WASHINGTON STREET PARK

Project No. 71-16-SP50

Addendum #3

DETAILS CONFLICTS WITH EXISTING UTILITY BOXES AND JACK SYSTEM.

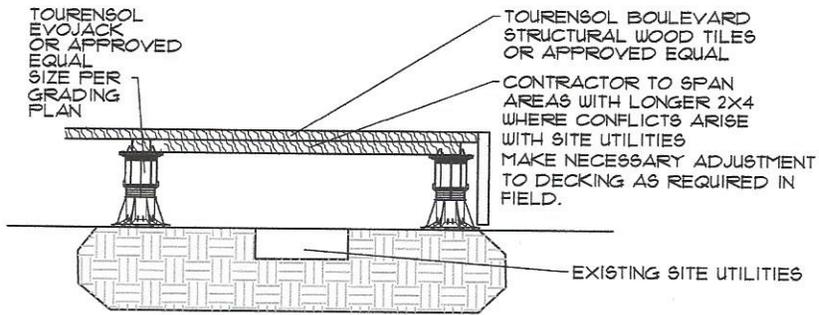
- A: See attached 8.5x11 for revised elevations.
- Q: What about the piers and the existing telecom fiber box located near the natural gas service. We can't pour over top of the lid and it's too big to place piers around the edges and still hit the correct spacing for the deck tiles.

- A: See Attached 8.5x11 detail.
- Q: What about the existing wrought iron arches? Arch "A" is bent inward at the top and the leg of arch "B" is bent as well.
